*Project: Replacement of 230kV Breaker AL25 at Sarnia-Scott TS*

***CAA ID No. 2002-EX098***

#### ***SARNIA-SCOTT TS - Replace existing 230kV breaker AL25***

**DIAGRAM 1**

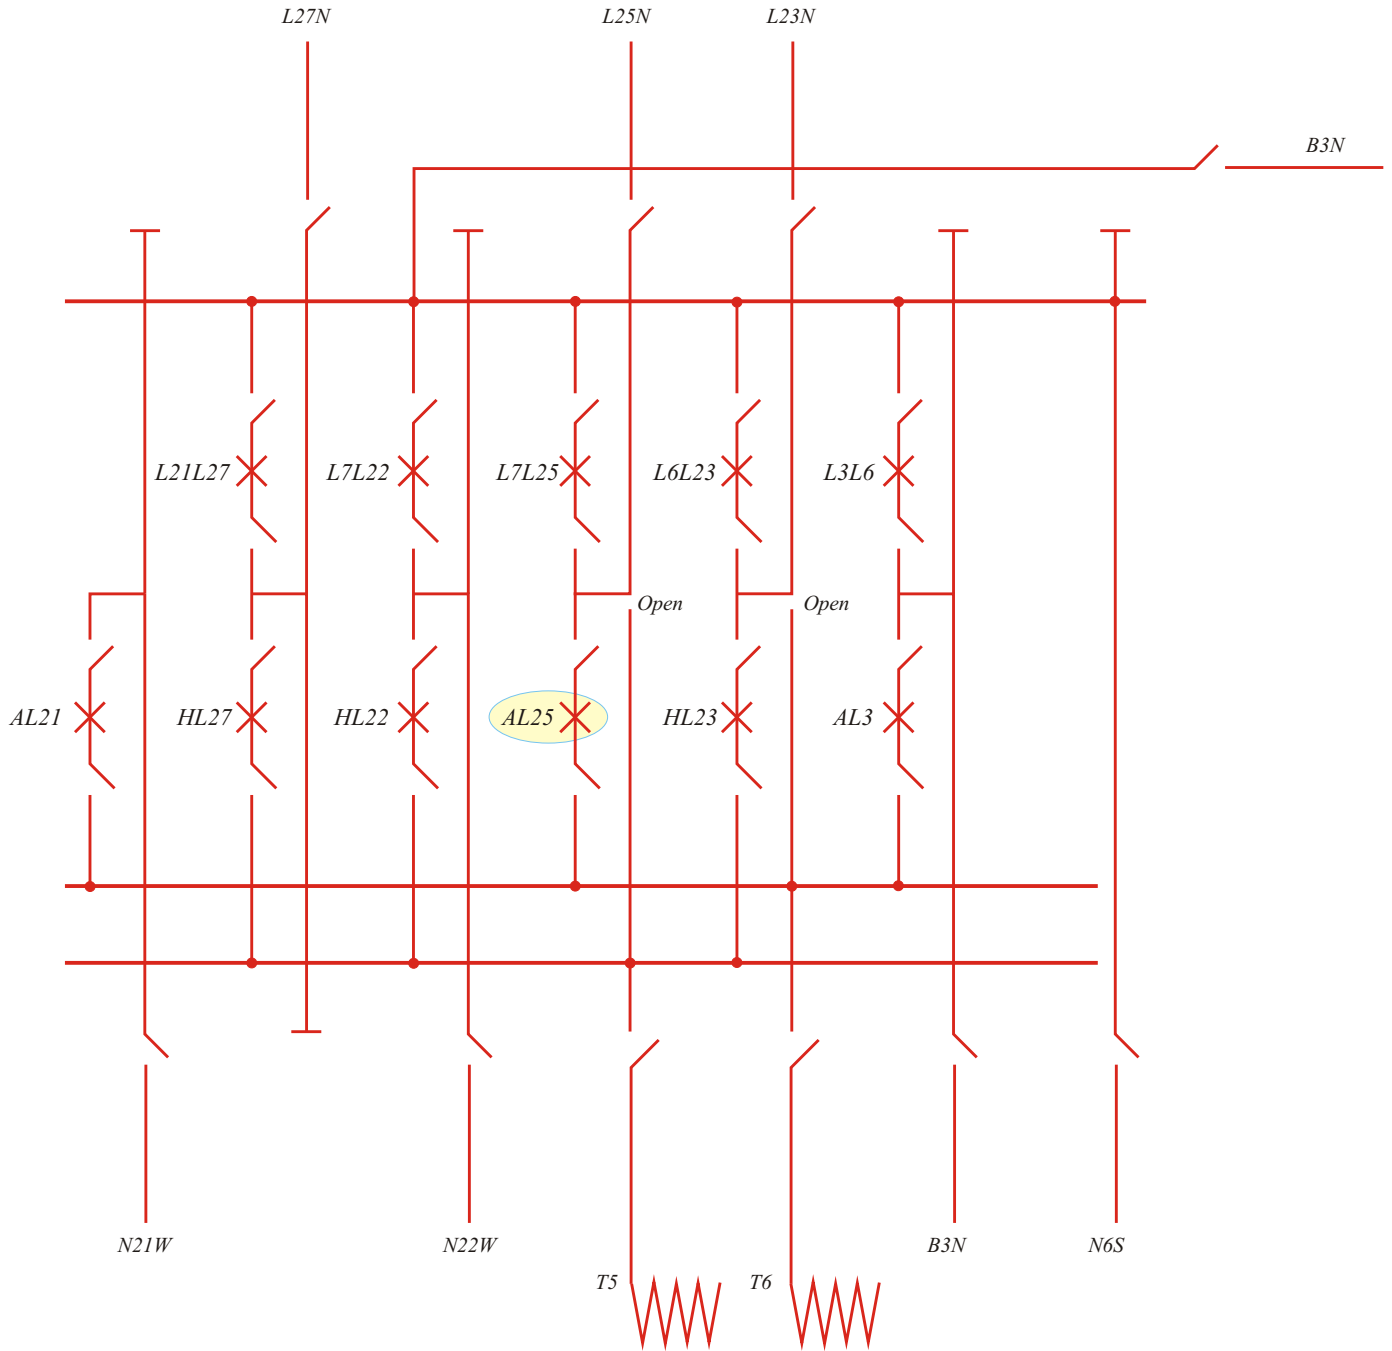
Although the new breaker has a superior fault interrupting capability to that of the existing breaker, the replacement is essentially a like-for-like exchange, and will therefore have no adverse impact on the IMO-controlled grid.

It is therefore recommended that a Notification of Approval of the Connection Proposal be issued.
